工程指示 / 要求簡箋(E.I.)

工程指示編號：EI / 3758 / 21

工程名稱：亞皆老街中電

工程項目：百葉 後加百葉鋁料(T3, UR/F、T1,2 R/F、T1,2,3 23/F) (7 隻)

Subject Description: Confirmation of Additional Opening and Louvre for Top Vent at T1-T3 TR/F ST-01 and T1-T3 23/F ST-02

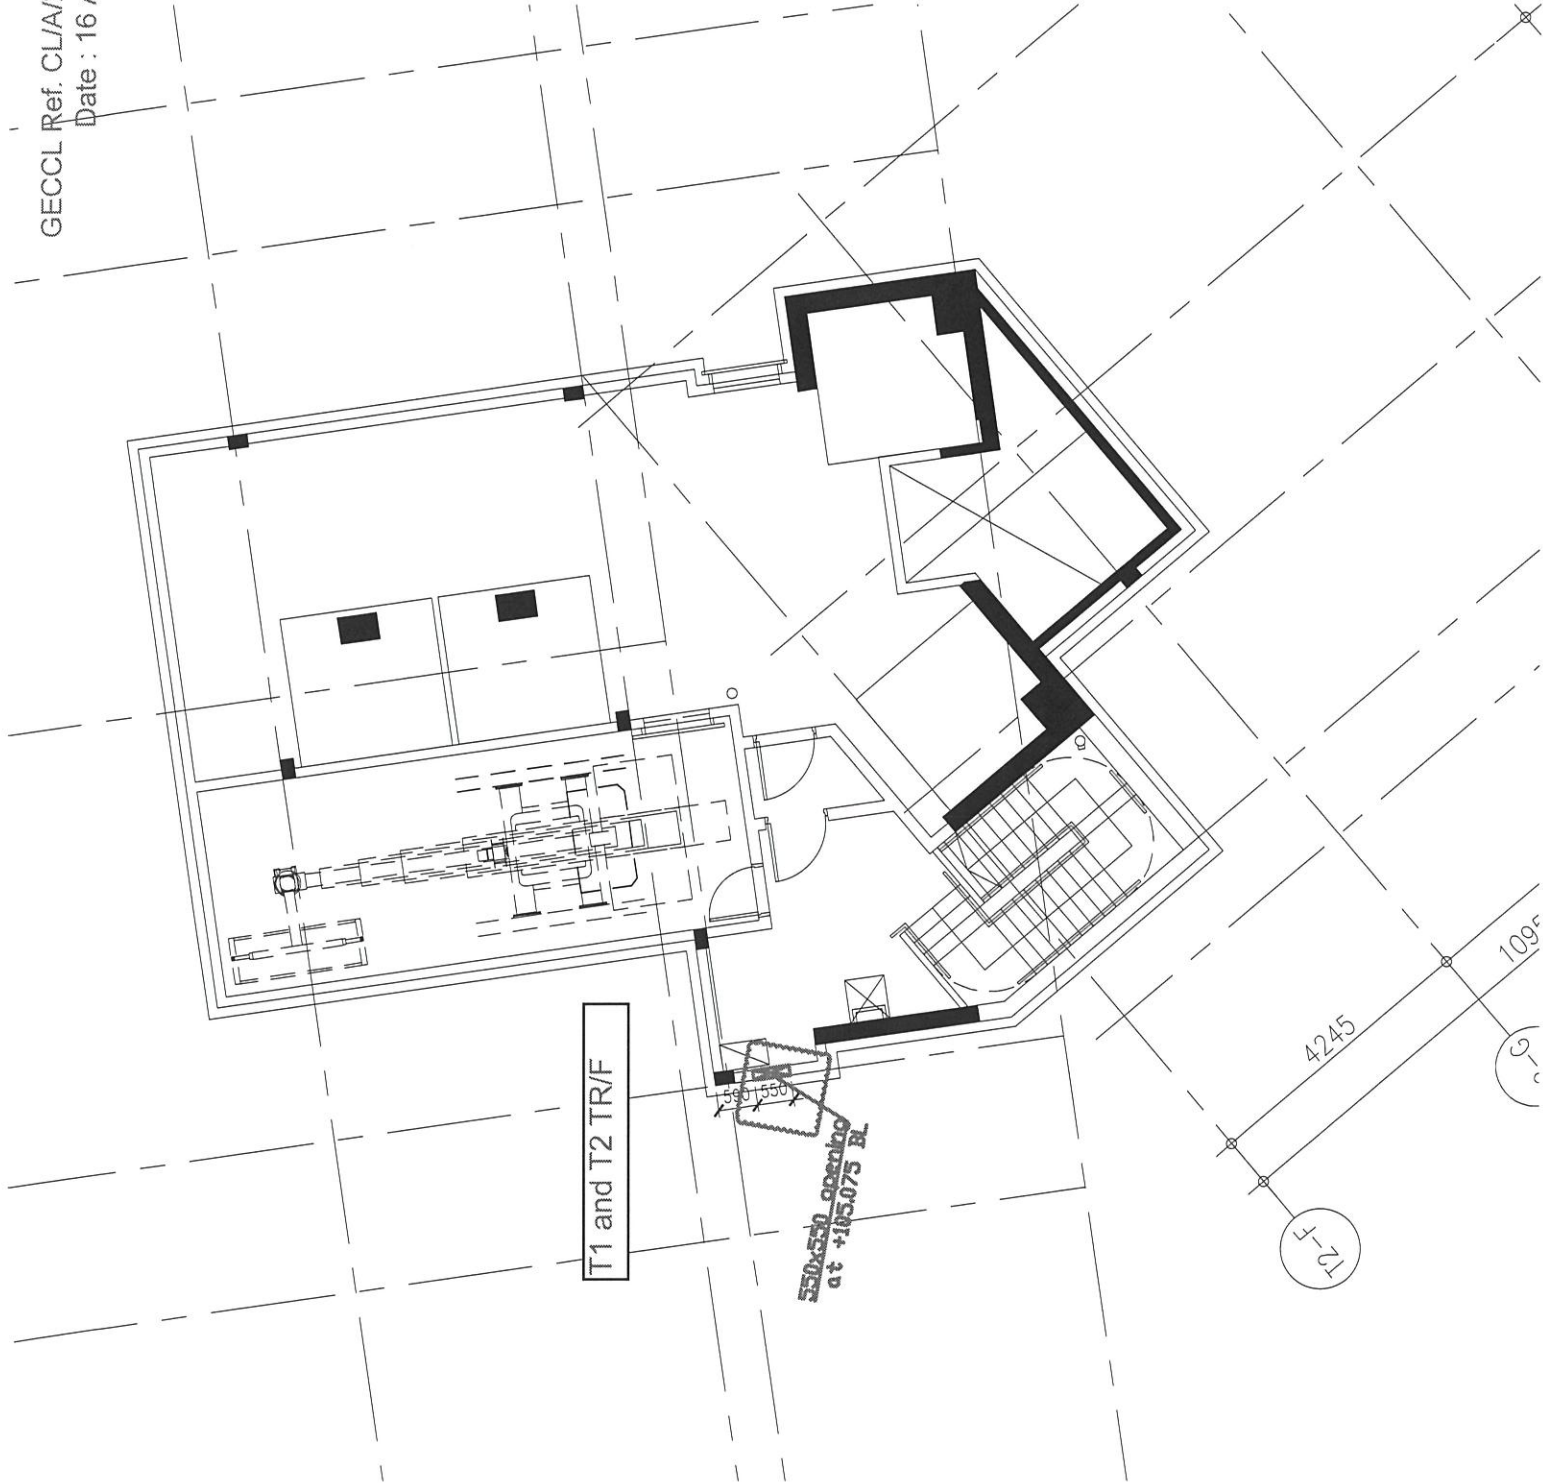
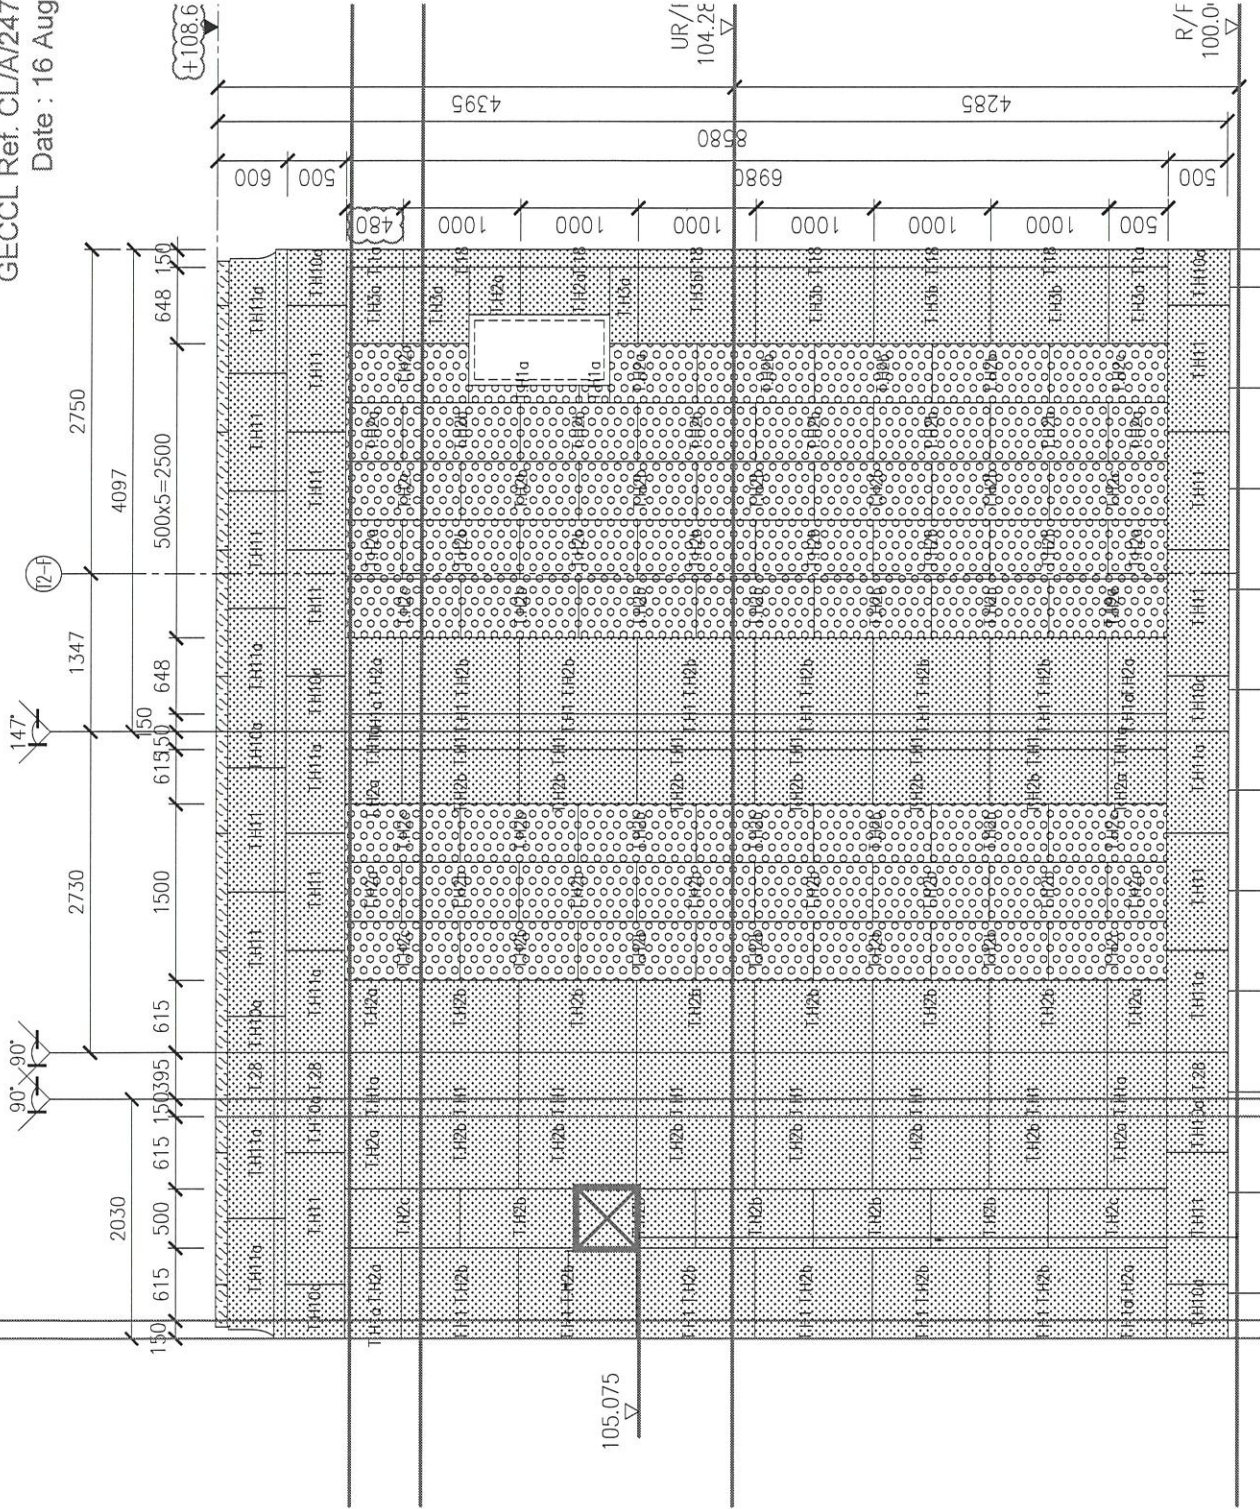
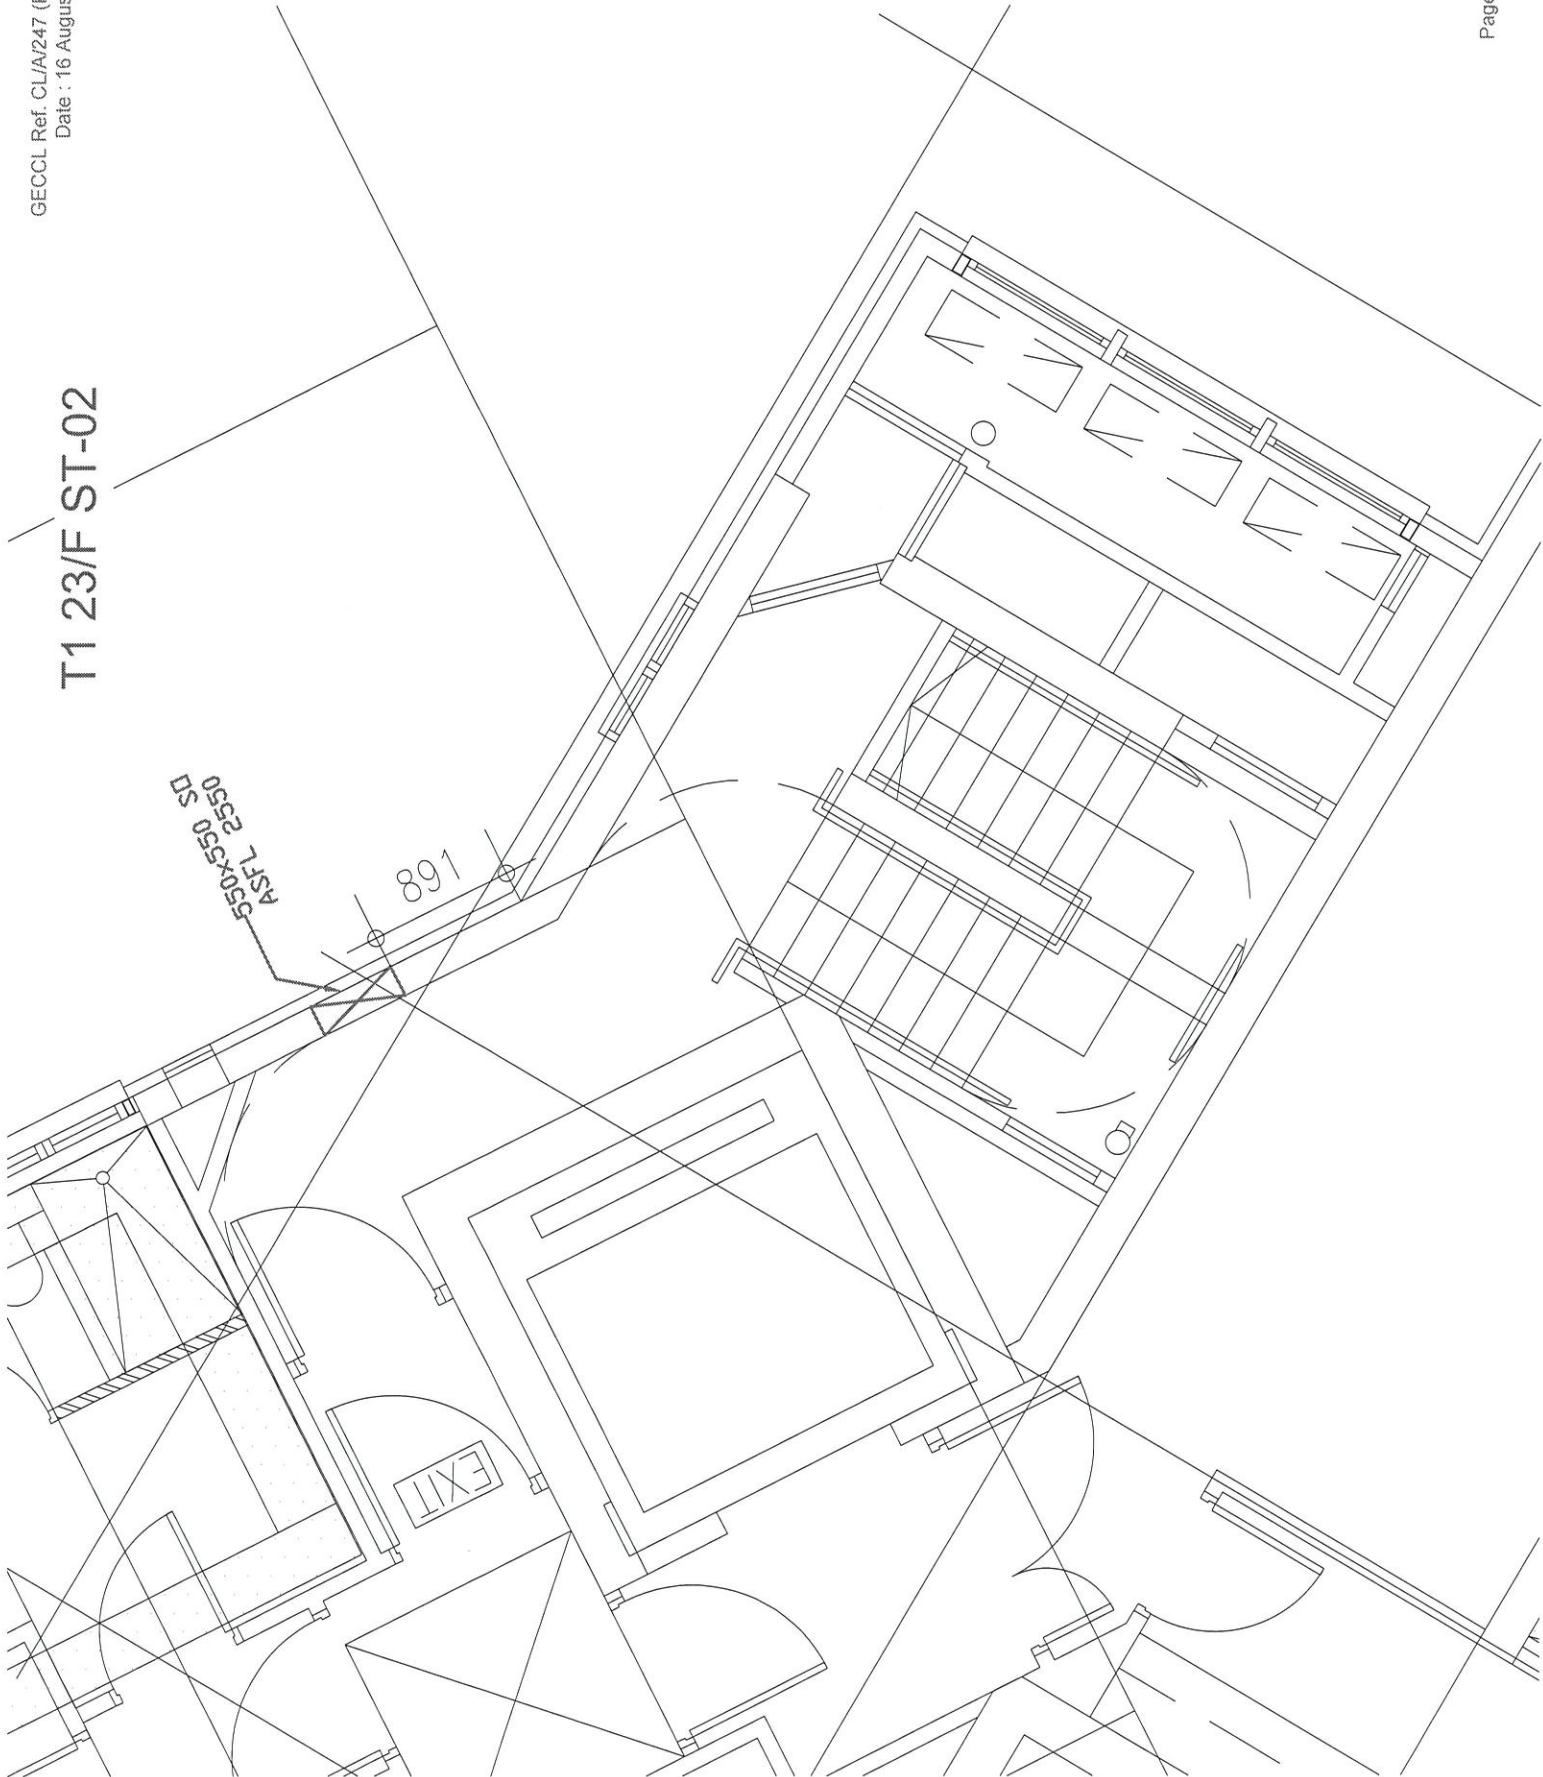
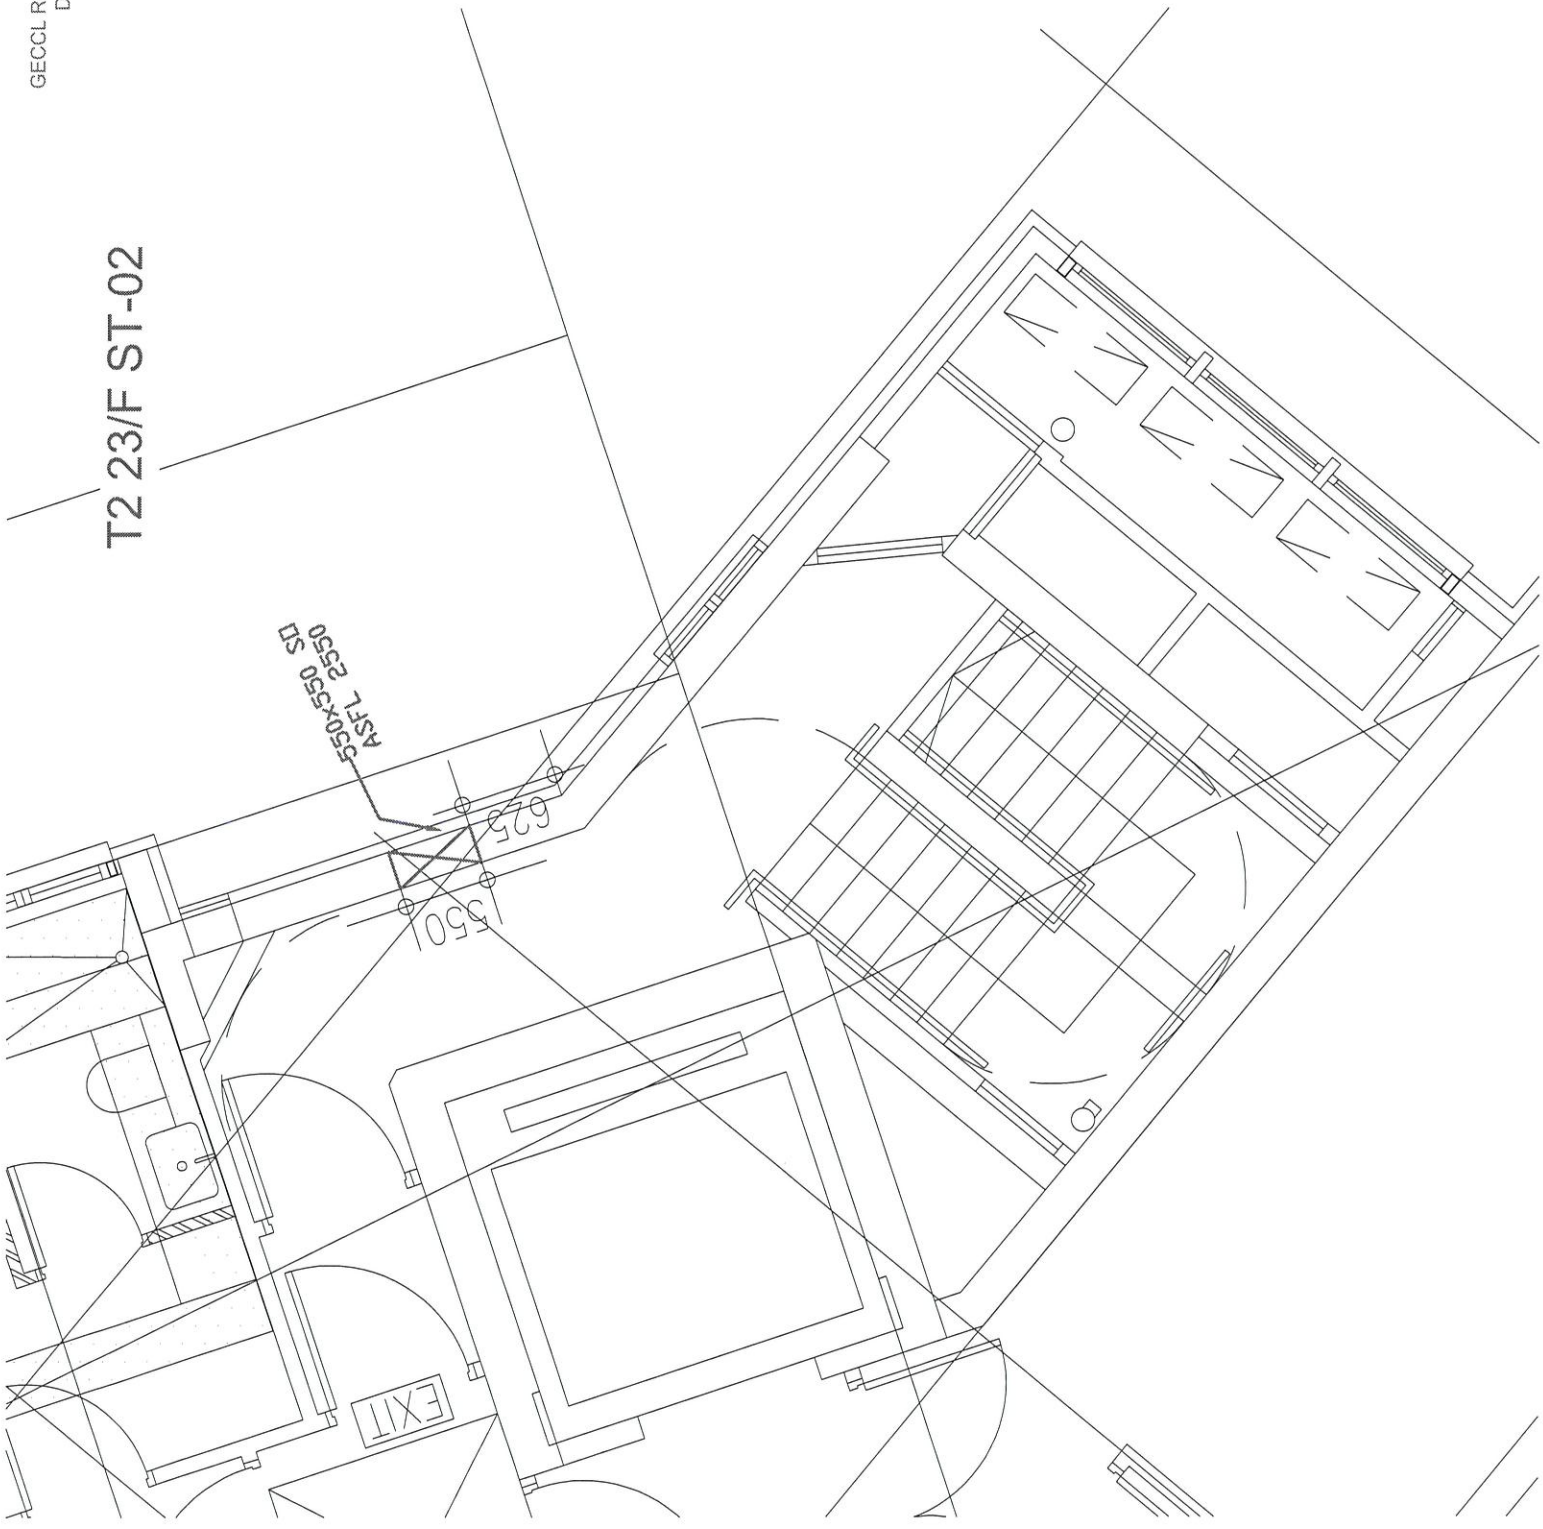
Further to telephone conversation with AGC on 12 August 2021, additional opening (550x550 S.O.) and louvre (500x500) to be supplied and installed by Midi was confirmed to be constructed for top vent at T1-T3 TR/F ST-01 and T1-T3 23/F ST-02.

550x550 opening
at +105.075 BL

ASFL 2550
550x550 SD
